NUCLEAR REGULATORY COMMISSION

Title: Advisory Committee on Reactor Safeguards

Regulatory Policies & Practices Subcommittee

Date: September 30, 2014

Incorporation of AHEX-E

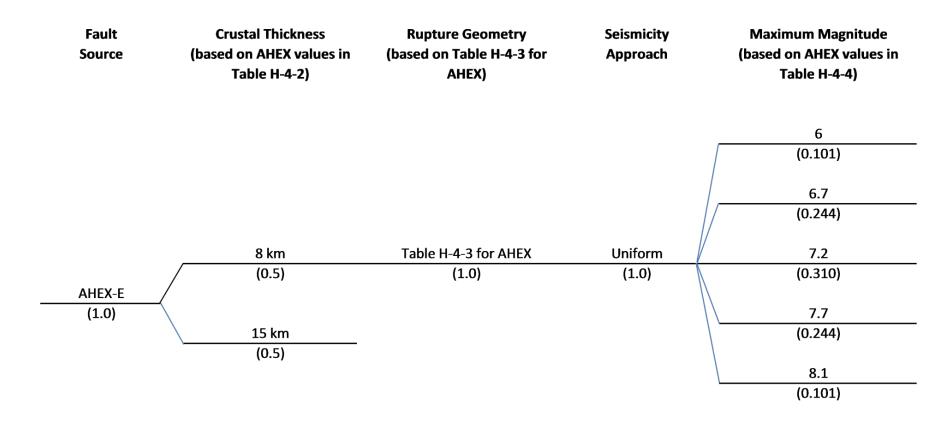
There was a small zone that was in our 200 mile radius that fell outside the CEUS study region which I'll talk about later, and we called that AHEX-E, Atlantic Highly Extended Crust East, just to incorporate that zone. It's a very low seismicity, there was only one event back in 1990. But for completeness, we added that zone.

MEMBER BLEY: I think Dana had mentioned that our consultant had posed some questions and we'd pass them on to the staff, but one of them I guess I'd like to read to you know and he talked about the zone you picked to fill in the rectangle, essentially, and it's a very low seismic region.

# Exposure Examined by NRC Staff during a 09/2011 Site Audit – No Field Evidence for Faulting

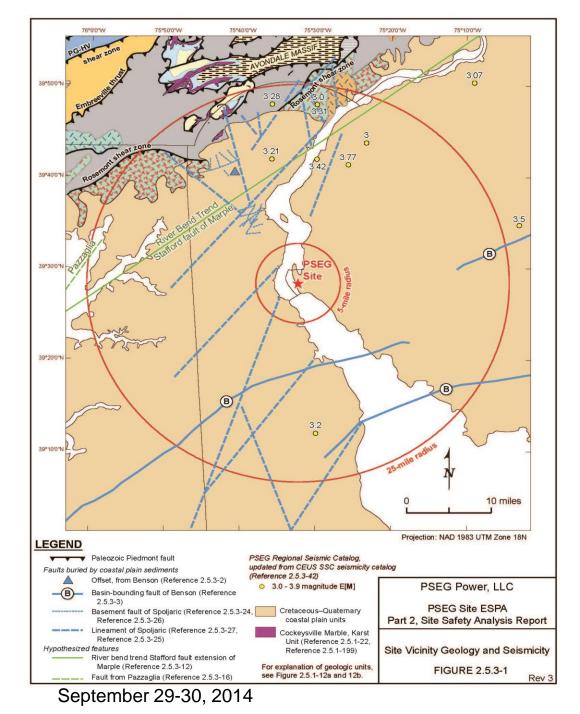
You do not see that in this exposure. So we felt that was good evidence that there's no field evidence for faulting. And this is sort of how you do it in geology. Any questions on 2.5.1 that I could happily enlarge on? No, I guess not. Okay.

### Modification of NUREG-2115 Seismic Source Model

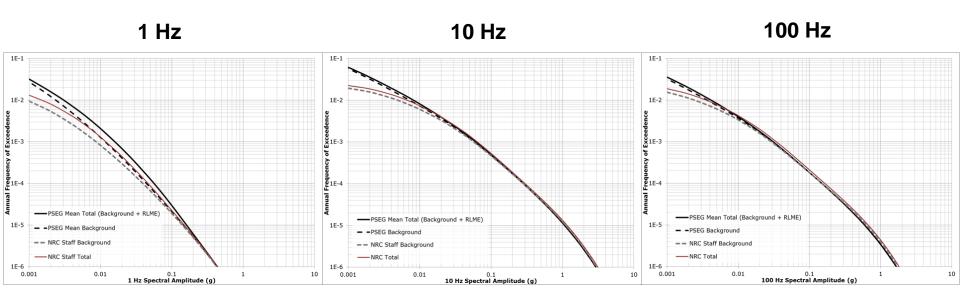
- <u>Issue</u>: In accordance with NUREG-2115, staff asked the applicant to justify seismic source model simplifications used in PSEG seismic hazard calculations
- <u>Resolution</u>: The applicant performed sensitivity calculations and compared the hazard from using the simplified point source model for background sources in the PSHA analysis to the hazard from using the finite rupture model as described in the NUREG-2115 model to show that the impact is minimal

- The applicant's sensitivity study specifically showed that for select individual seismic sources, the hazard curves at the 10⁻⁴ and 10⁻⁵ annual exceedance frequencies increase by up to 15% due to the use of full source rupture models
- Staff concluded that even though the individual seismic sources' hazard contributions maybe higher by up to 15%, the overall percentage increases in the total seismic hazard curves at the site are significantly lower
- Staff considers the differences calculated in this sensitivity study to be within the uncertainty in the overall PSHA calculations
